Contingency Allowance Expenditure Authorization

Project: HIDALGO COUNTY EL PARAISO HEALTH CLINIC & COMMUNITY RESOURCE CENTER

Authorization No. 01

Change Proposal Request	
Contract #	001
CPR #	001 R5
Issue Date	16-Oct-2024
Subject	ASI 001 Changes to Asphalt Drive

PAVING & DIMENSIONAL CONTROL PLAN

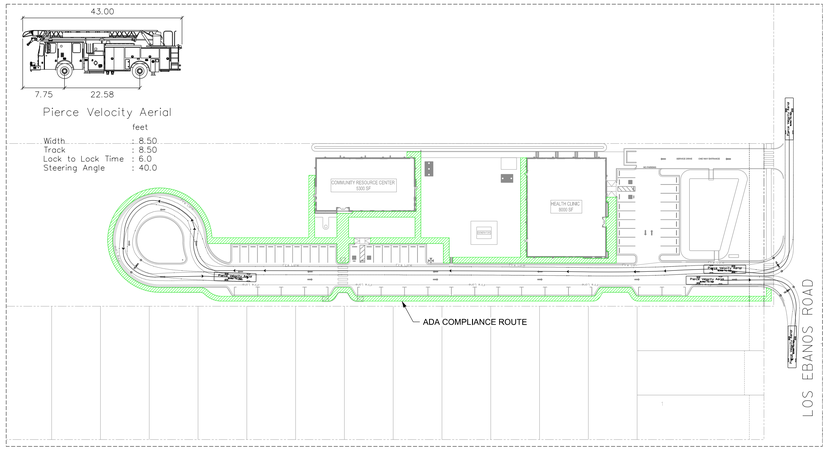
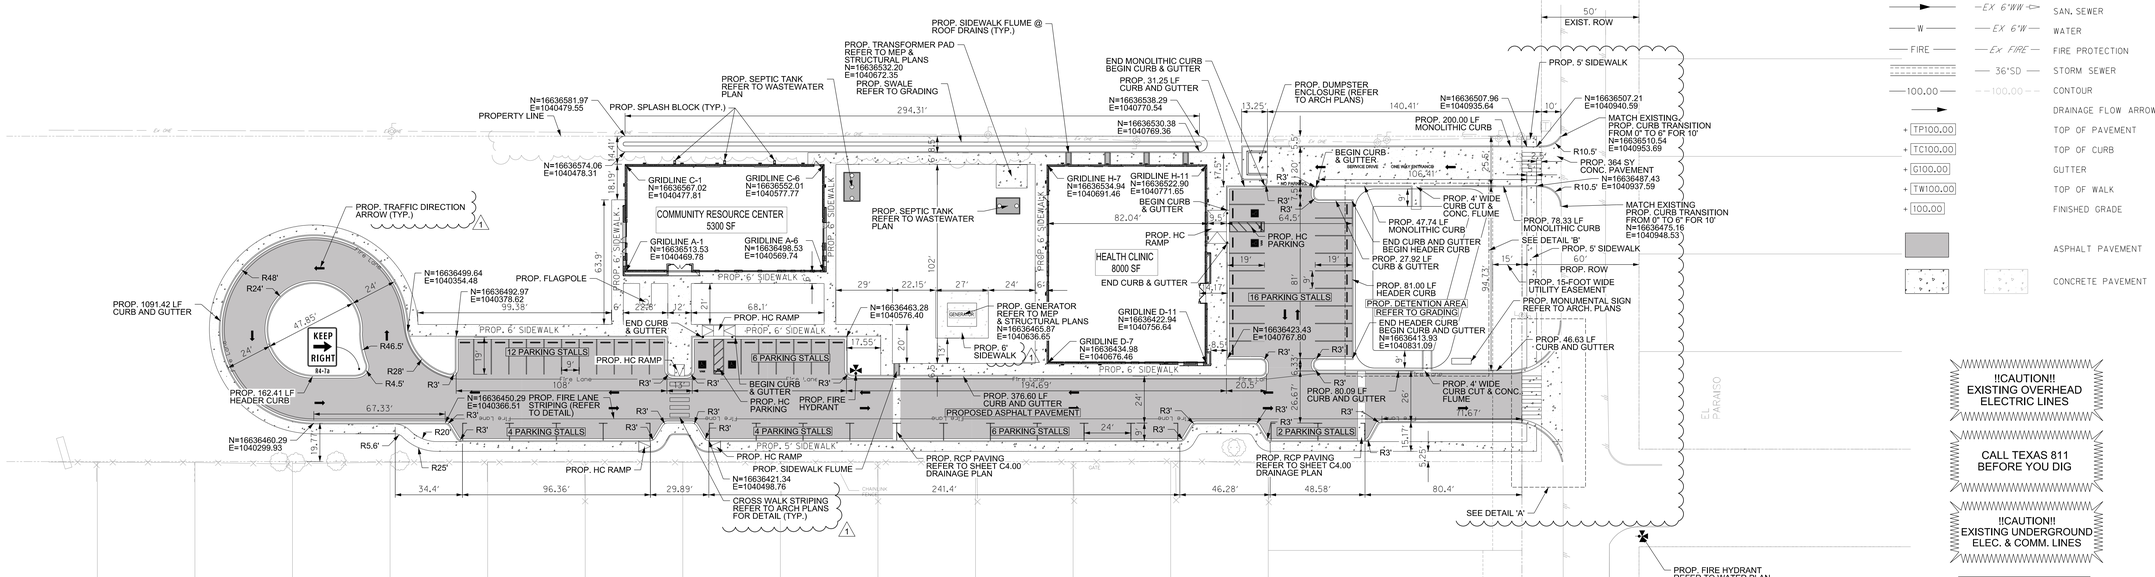
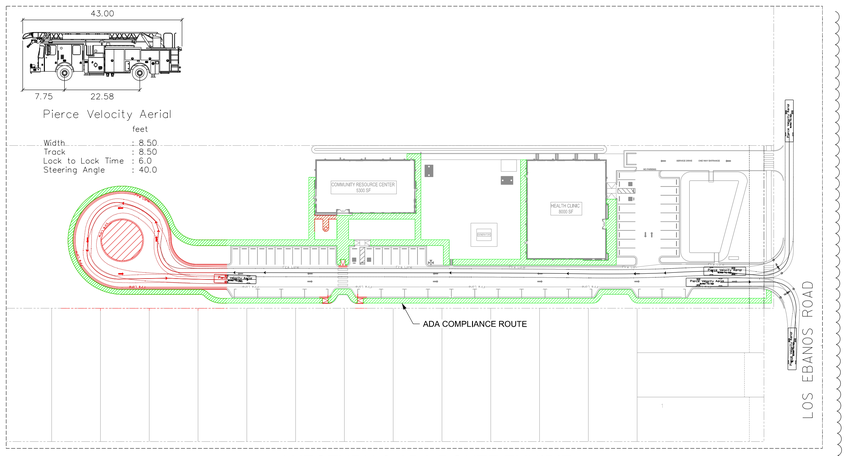
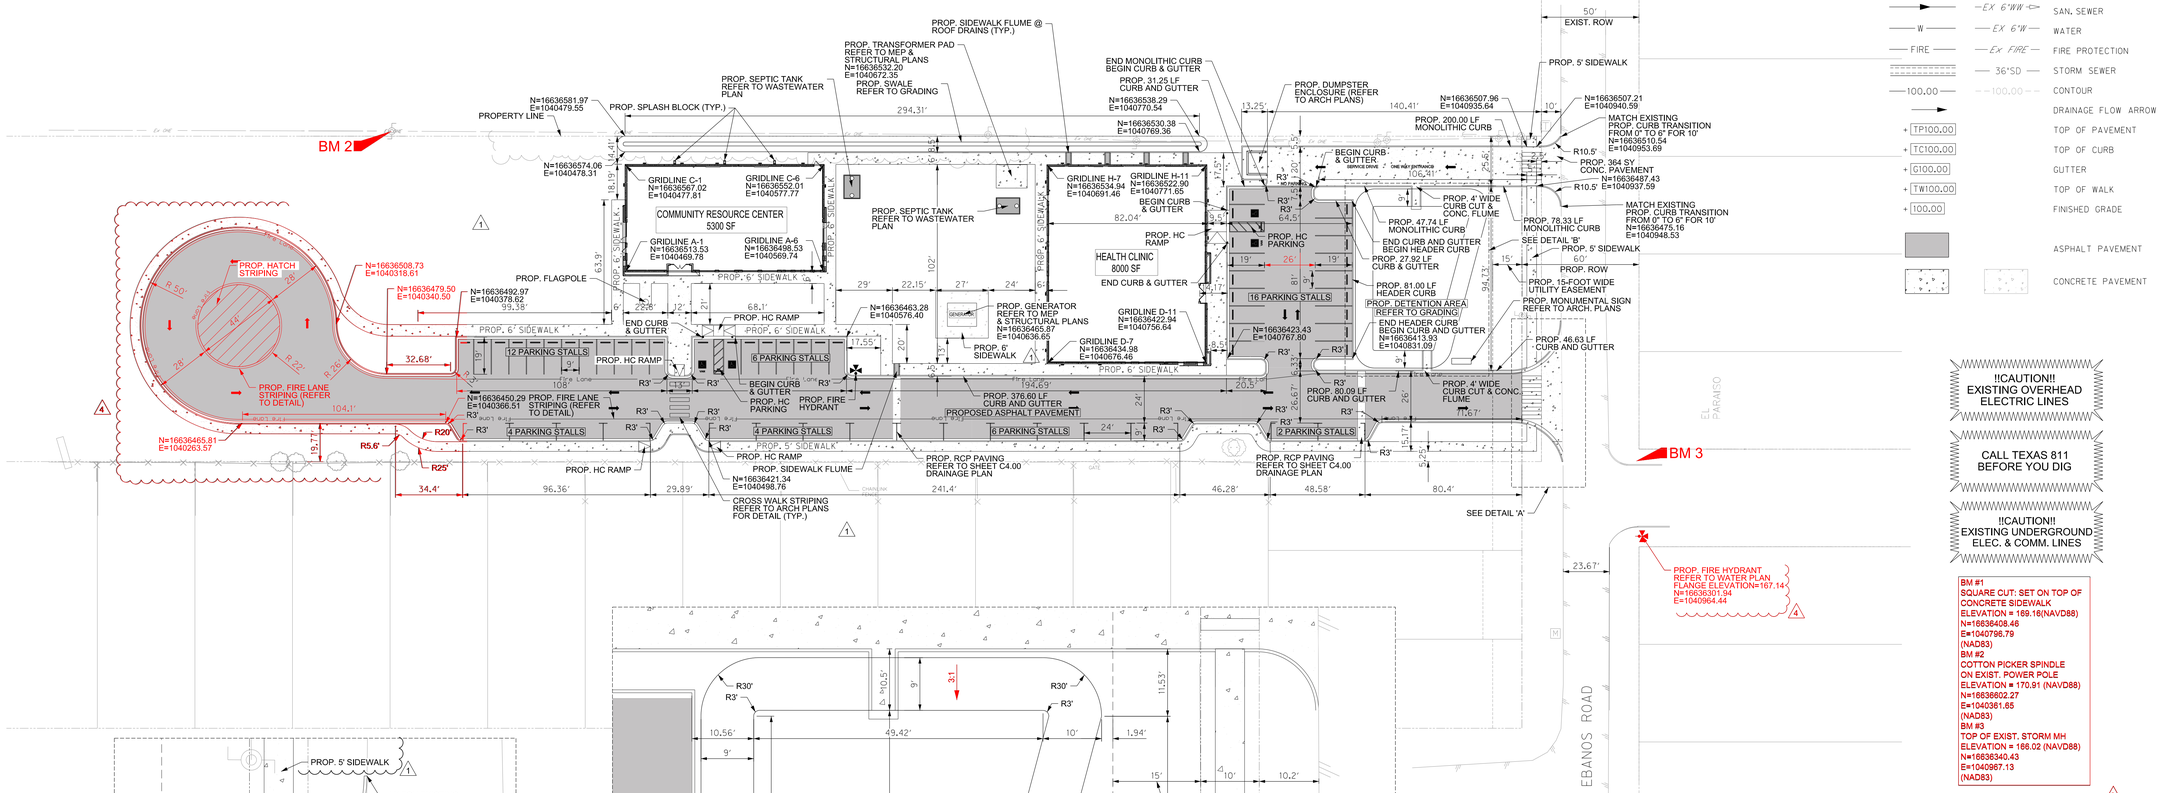
Scope of work identified below is aligned with ASI 001 and the revisions and clarifications based on building permit comments from Hidalgo County health department & fire marshall. The changes to the plan documents are identified below as Clouded (RED) & RED Lined . The additional cost for the extension of the drive for the turn around is depicted in the atchements. Keep in mind that the work being done is being priced at today's market prices and not when previously bid. This work is on going and we will need an answer by way of approval of CPR or CCD 002 or this will delay the production of the project.

WASTEWATER PLAN

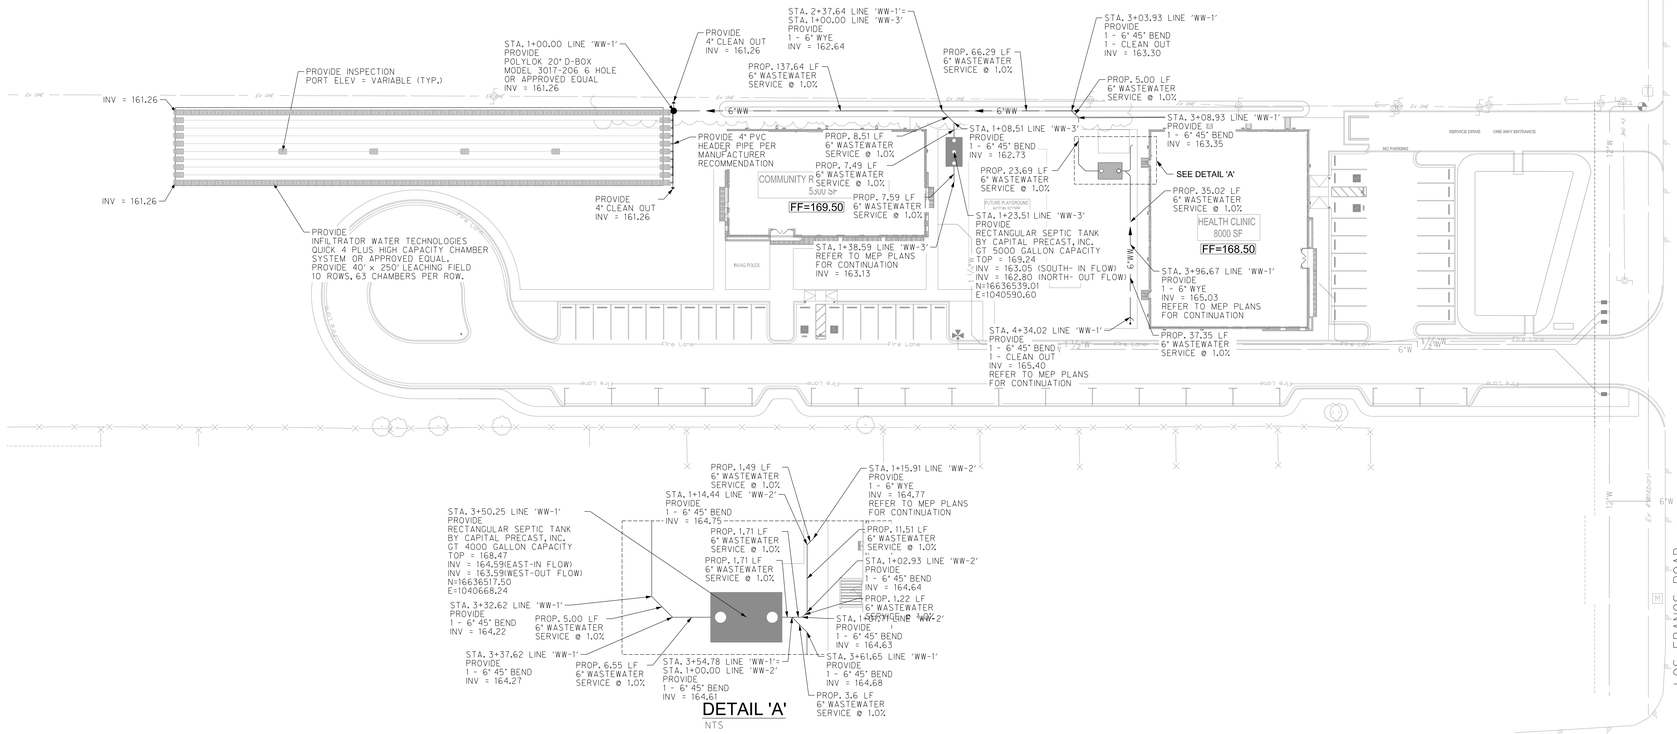
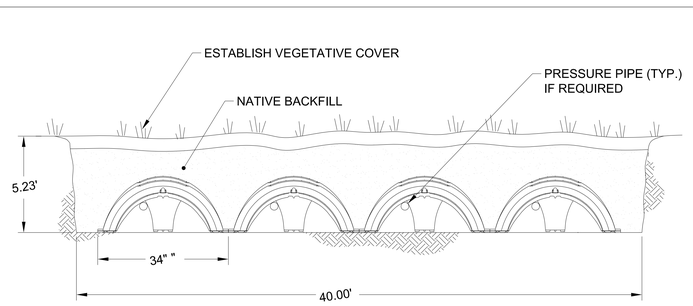
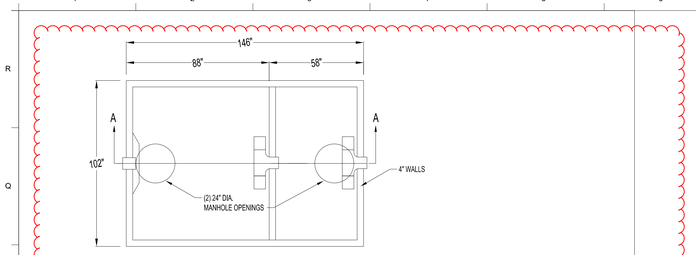
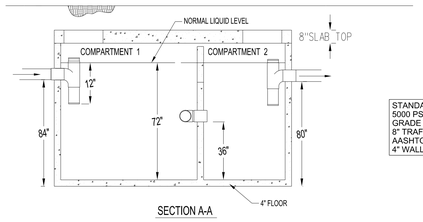
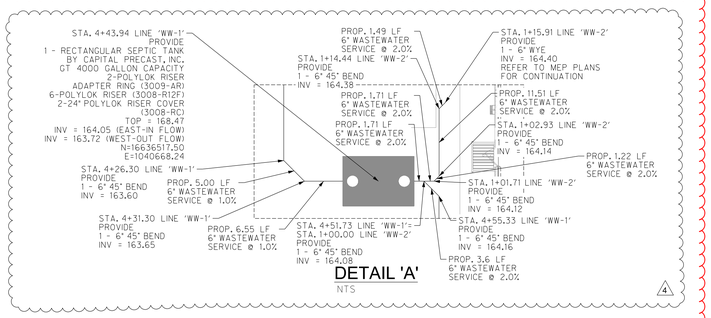
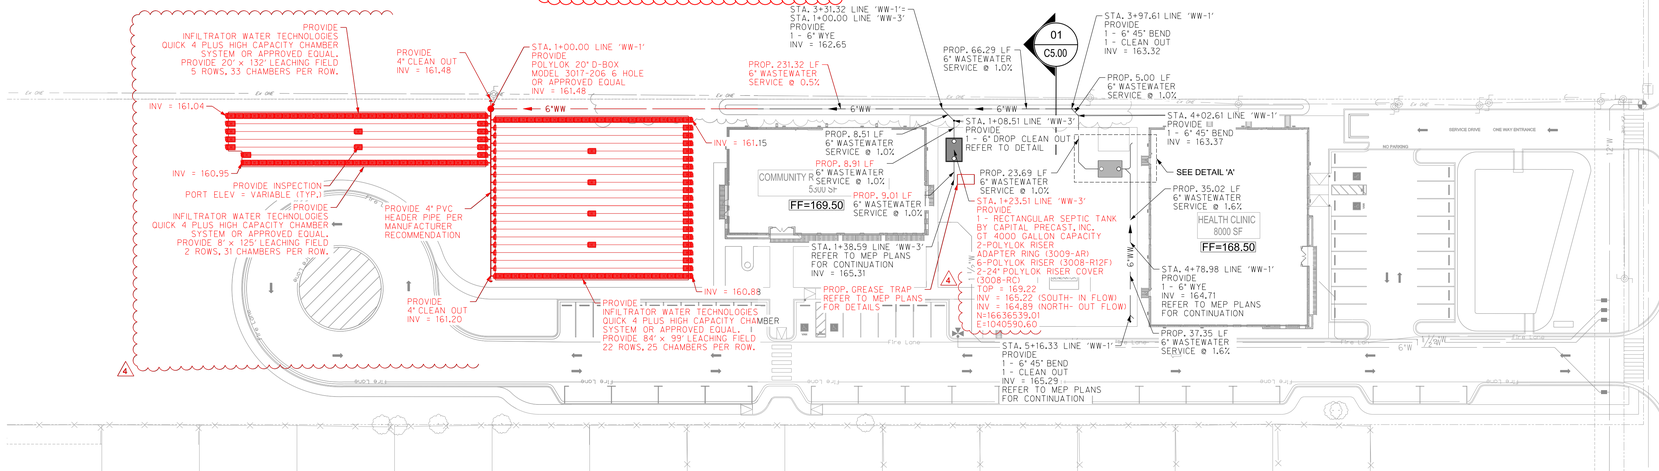
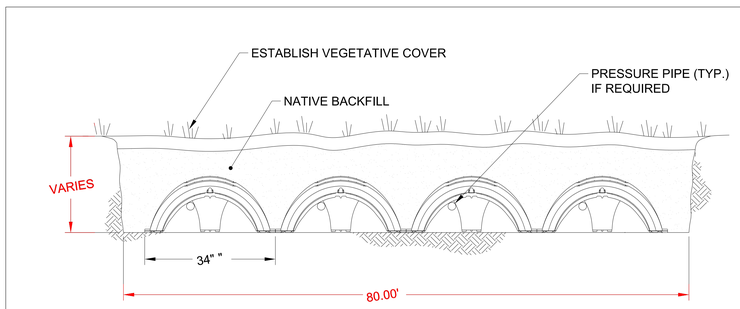
At the request of Hidalgo County regulatory and the Design team via ASI 001 requesting changes to the original contracted scope of work regarding the septic tank. The cost proposal provided is in direct alignment with revised sheet C5.00, specifically the septic tank size. Septic tank size was decreased from 5,000 gallon as per original contract documents to 4,000 gallon. Breakdown includes credit for original 5,000 gallon septic tank and labor and the price for the new 4,000 gallon septic tank and labor. Breakdown on following pages.

Sheet
L101

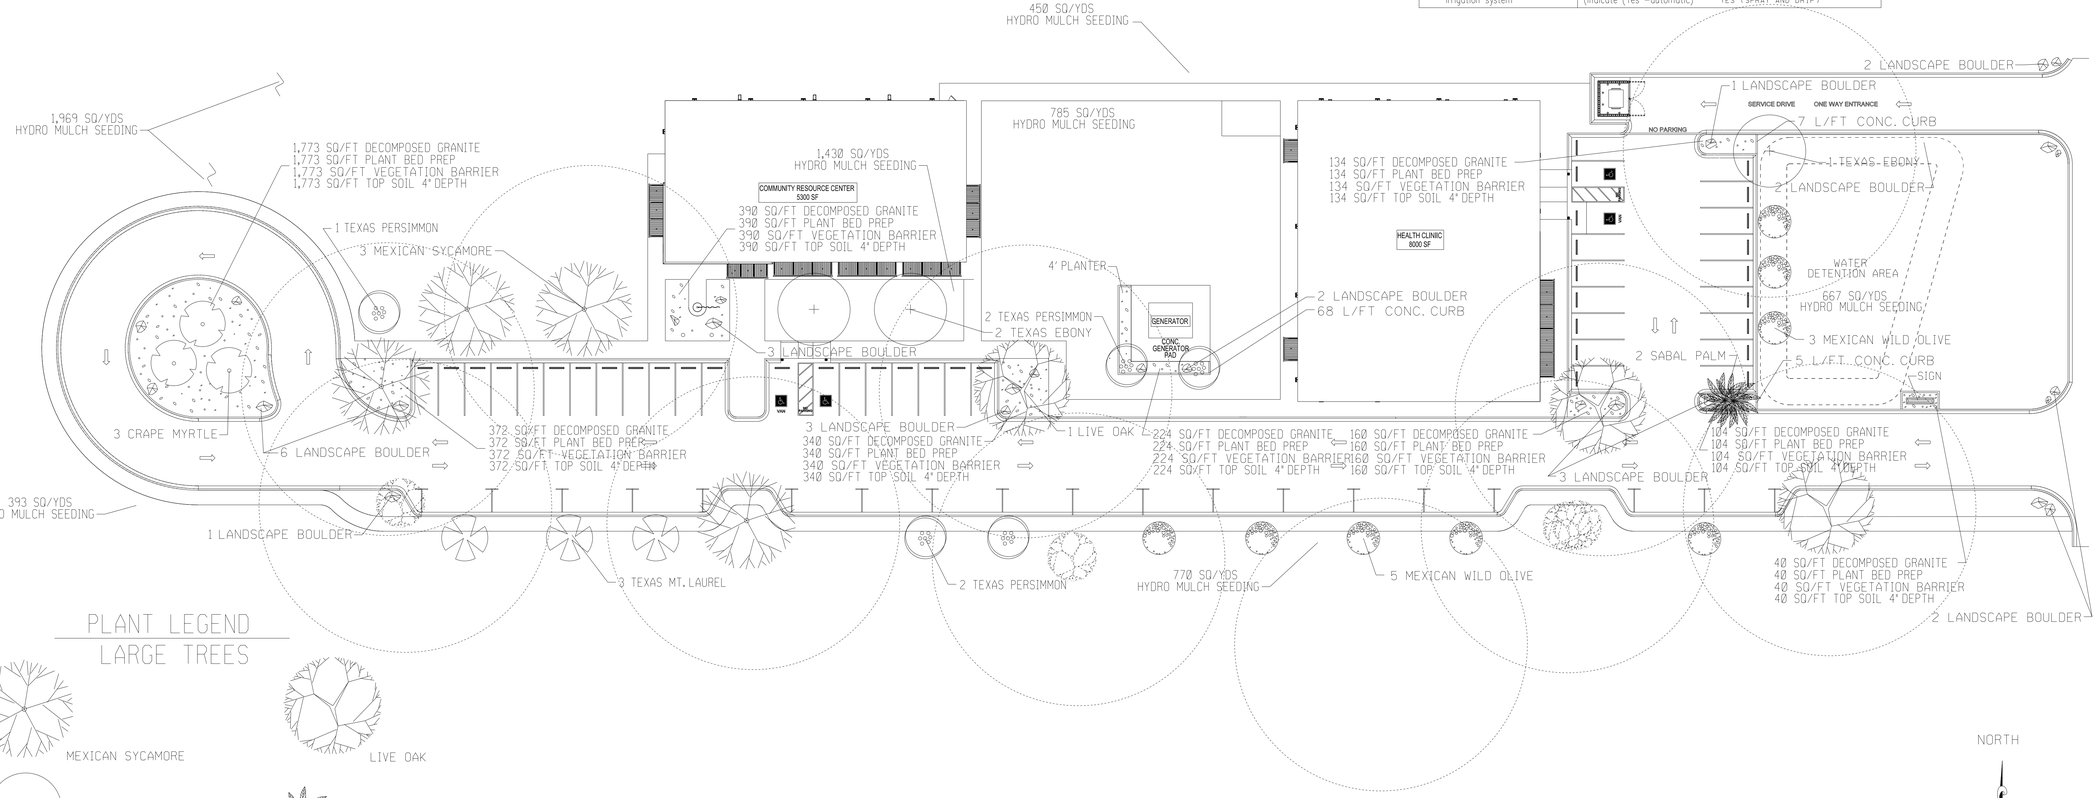
Changes to landscaping, irrigation and drive turn around as per ASI 002 include a credit to the Owner for trees, shrubs, decomposed granite, boulder quantities, and the addition of hydro-mulch, weed mate and irrigation bubblers, lawn sprinklers and an isolation valve to the scope of work in order to accommodate Hidalgo County's Health Department sewer plan requirements. Proposal breakdown is included in the attached documentation.

This is adding up what is on the plans as highlighted above.
